October 2020
FL860AB
NHTSA #20V-527
Transport Canada #2020-408

Subject: Freightliner Engine Harness Clearance

Models Affected: Specific Model Year 2018-2021 Freightliner 108SD, 114SD, and Business Class M2 vehicles manufactured May 24, 2017, through August 26, 2020, and equipped with a Detroit Diesel DD8 engine.

Fig. 9, Eight Inch Horizontal Section of TwistTube

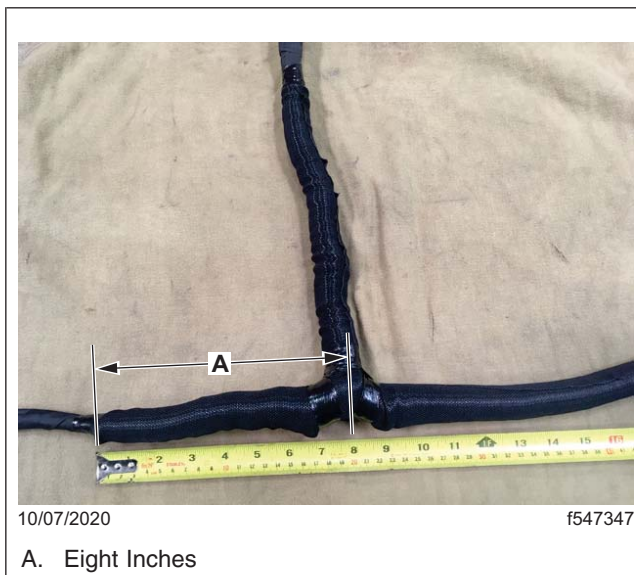
Add TwistTube over the first 8 inches (203 mm) of the horizontal section ahead of the vertical section (see [Fig. 9](#)) and over the first 18 inches (457 mm) behind the vertical section (see [Fig. 10](#)). There will be a total of 26 inches (660 mm) of added TwistTube. See [Fig. 11](#).

Fig. 12, 12-Inch Vertical Section of TwistTube

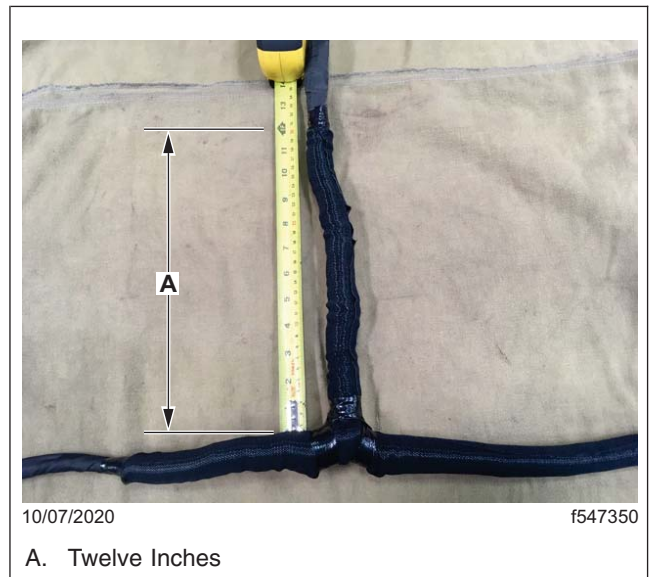
Add TwistTube over 12 inches (304 mm) of the vertical section, starting at the horizontal section juncture. See [Fig. 12](#).

Fig. 13, Current Air Compressor Mounted Bracket Showing Area of Possible Harness Rub

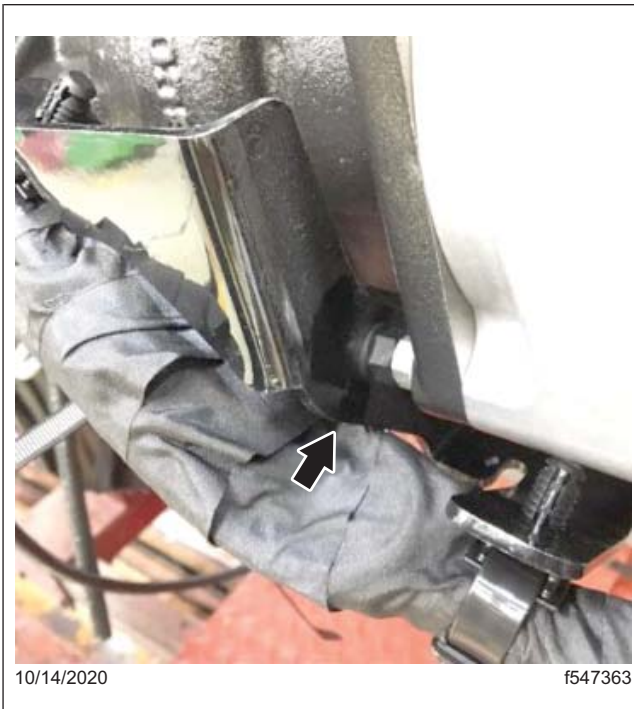
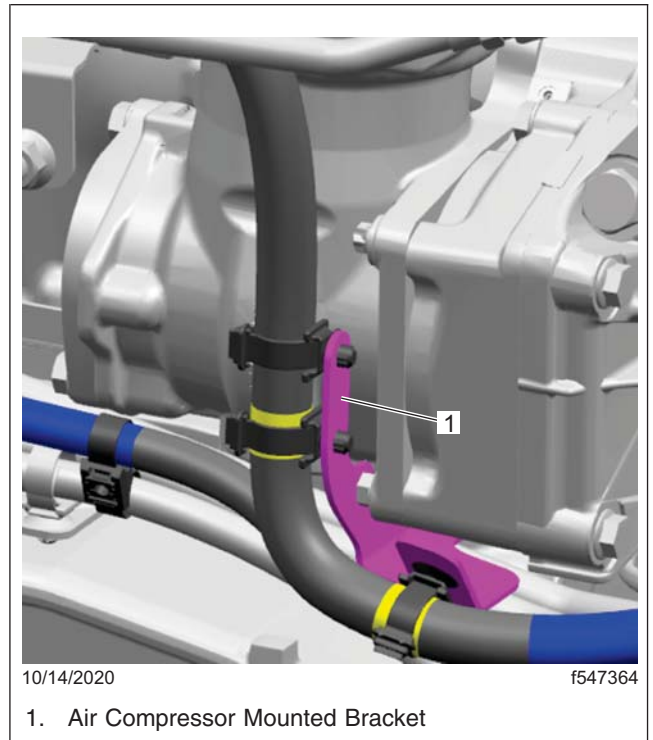
1. Replace the existing air compressor-mounted bracket (see [Fig. 13](#)) with the one supplied in the kit (part number 66-13326-000). See [Fig. 14](#).
 - 1.1 Remove the two fasteners securing the old bracket to the air compressor and remove the bracket.
 - 1.2 Install the new bracket (part number 66-13326-000) then torque the fasteners 27 to 32 lbf-ft (36 to 43 N-m).

Fig. 14, New Air Compressor Mounted Bracket, Back View

Fig. 16, Existing Standoff Bracket

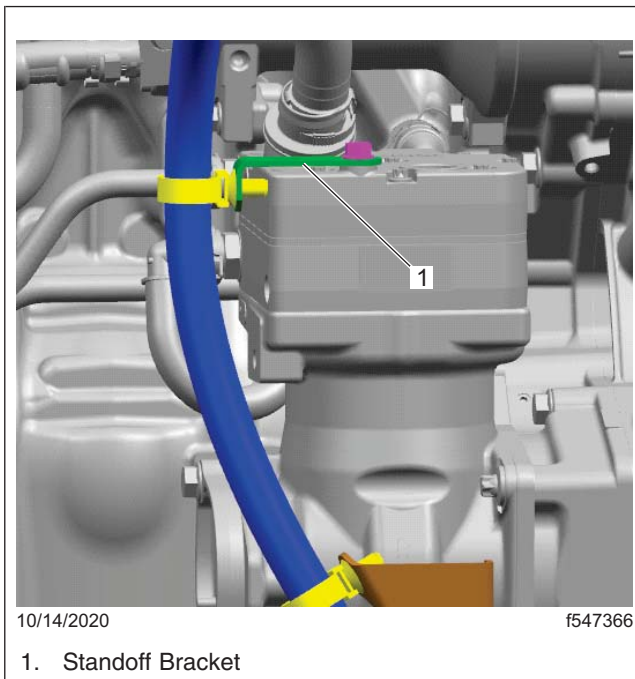
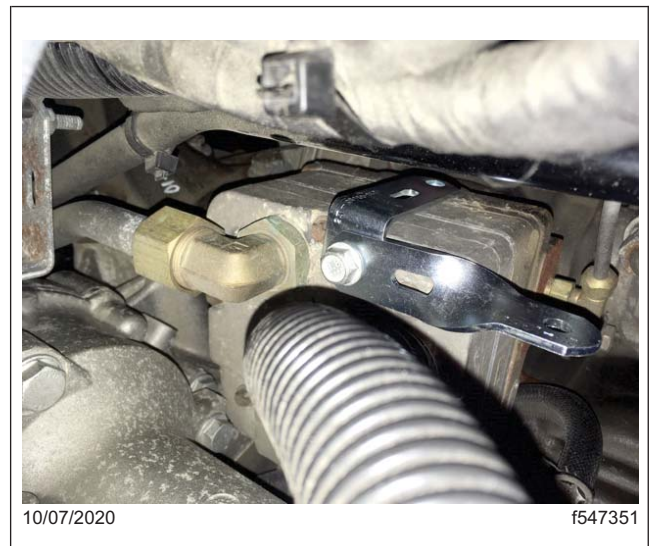
- 1.4 To secure the vertical section of the harness on the new bracket, install fir tree fasteners with tie straps (part number 23-14137-001) in the two holes. See **Fig. 15**.
2. Remove the existing standoff bracket and install the two new brackets.
 - 2.1 Remove the existing standoff bracket bolted to the top of air compressor. See **Fig. 16**.
 - 2.2 Install the new brackets onto the top of air compressor where existing standoff was removed. See **Fig. 17**. Install the parts in the following order:
 - washer (part number 23-09114-011)
 - standoff bracket (part number 23-09130-017)
 - standoff bracket (part number 23-13516-001)
 - M8 bolt (part number 23-13345-025).
 - 2.3 Torque the fastener for the brackets to 27 to 32 lbf·ft (36 to 43 N·m).

Fig. 17, New Standoff Bracket

Fig. 18, Harness Secured to Both Standoff Brackets

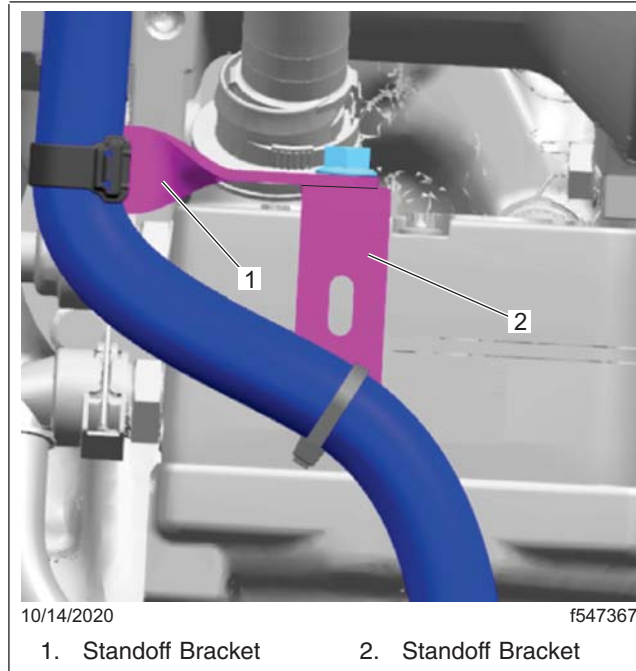
3. Secure the engine harness to the standoff brackets. See **Fig. 18**.
 - 3.1 Use two fir tree fastener tie straps (part number 23-14137-001) to secure the harness to the brackets; after installing tie straps make sure the harness is not contacting any part of the compressor.

Fig. 19, Population B: Existing Standoff Bracket

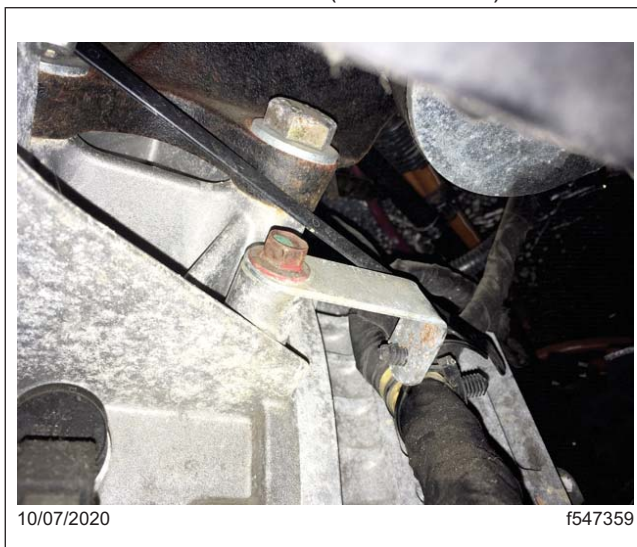
1. Replace the existing standoff bracket (see **Fig. 19**) at the left side of the flywheel housing with a new stand-off bracket from the kit (part number 23-13514-021). See **Fig. 20**.
 - 1.1 Install the bracket using the new washer (part number 23-09114-001) and the existing bolt and torque to 27 to 32 lbf-ft (36 to 43 N·m).
